Subject: Pre-perc site review, 1690 Barlow Lane, Sebastopol, CA
APN 061-050-055 SEV04-0720

Pre-Perc Field Notes

Report of Investigation

Site 1

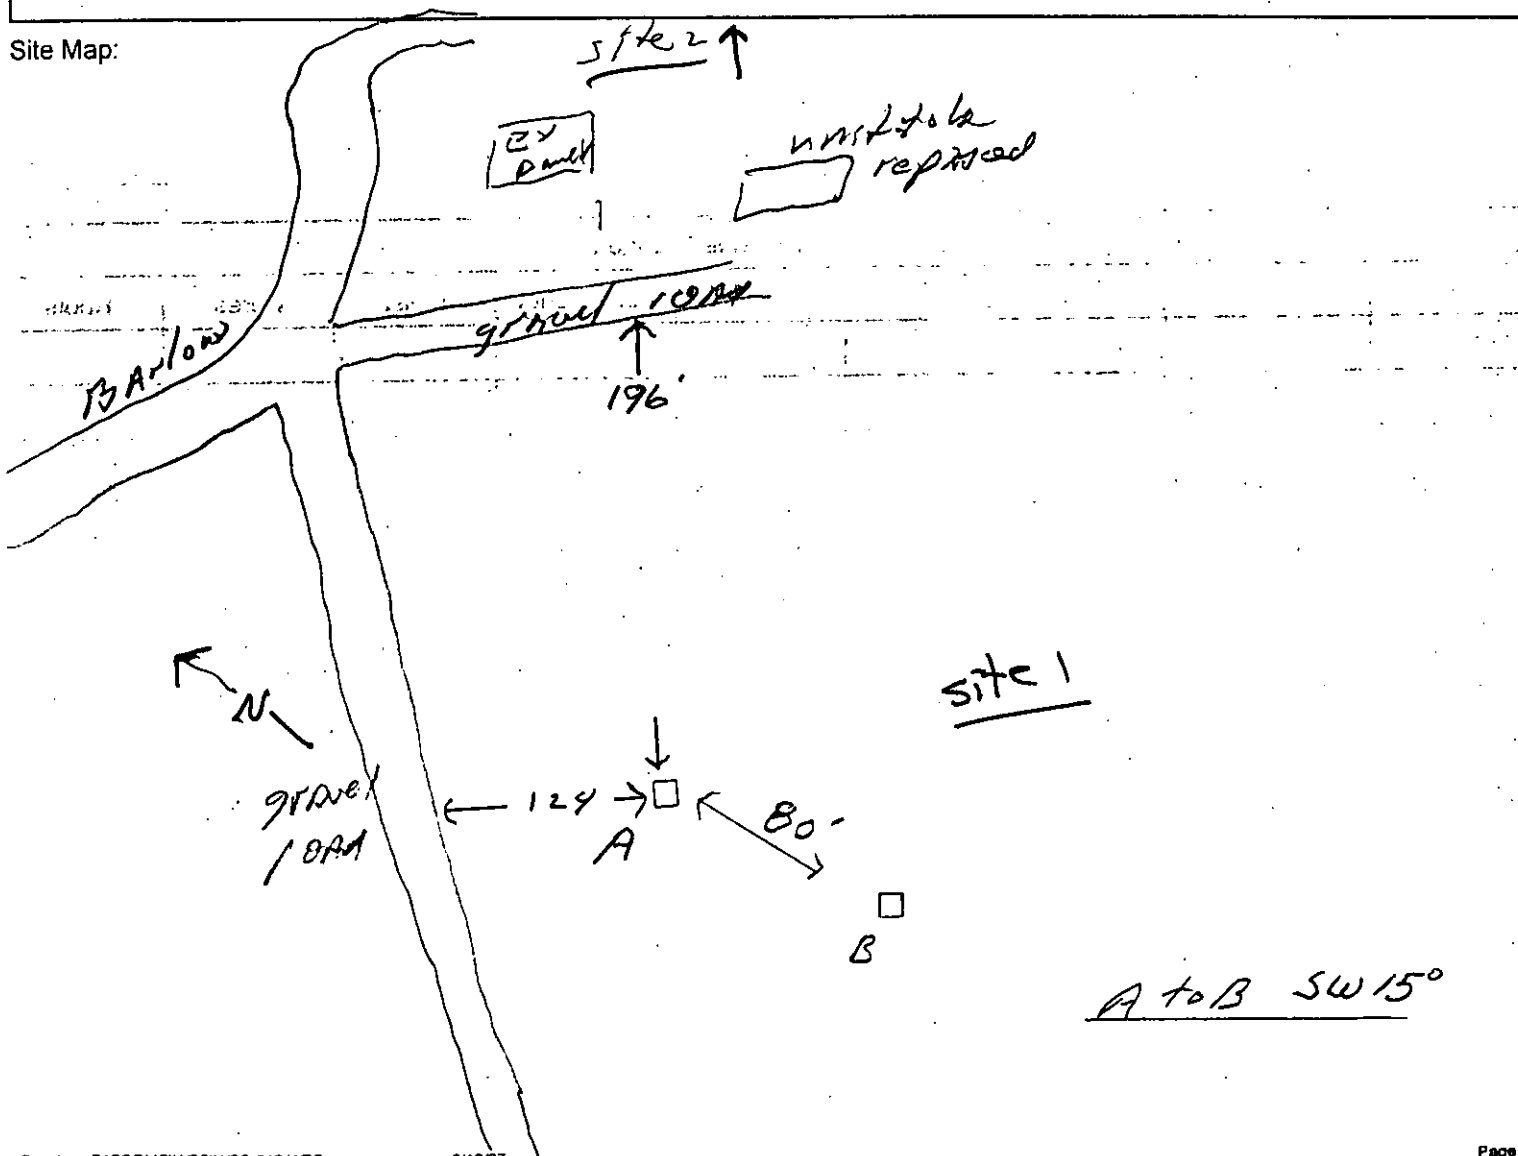
Other: ok to extrapolate using elevation difference GW's ±100' above.
0.6g/ft to 30"

Profile holes A & B / site 1 west of house - ok to place a 30" standard using 30 mpi, 125' bedroom provided groundwaters run in 1996 approximately 110' upslope towards house extrapolate area to provide the required 36" separation to groundwaters.

Site 2

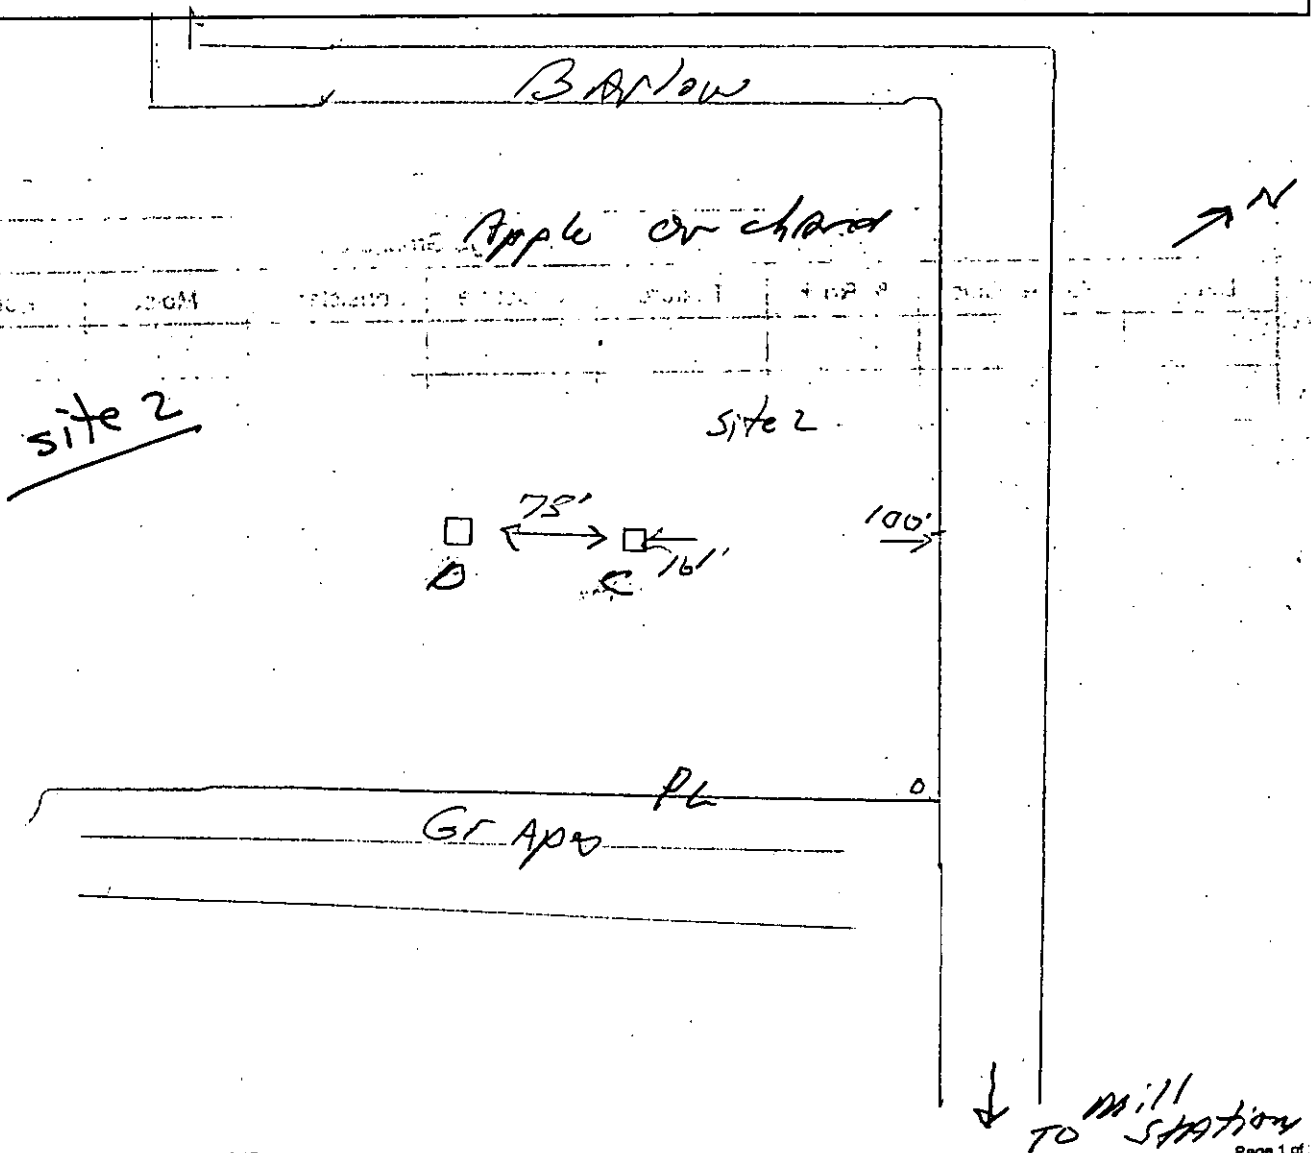
Profile holes C & D / site 2 - east of house - Good soils to 104/107 inches

Need to run groundwaters. If pass for a standard ok to design a 30" standard at 125' bedroom to 44" by hole D size at 30 mpi if pass groundwaters or to 48" by both using 0.5 g/f² = 130' bedroom
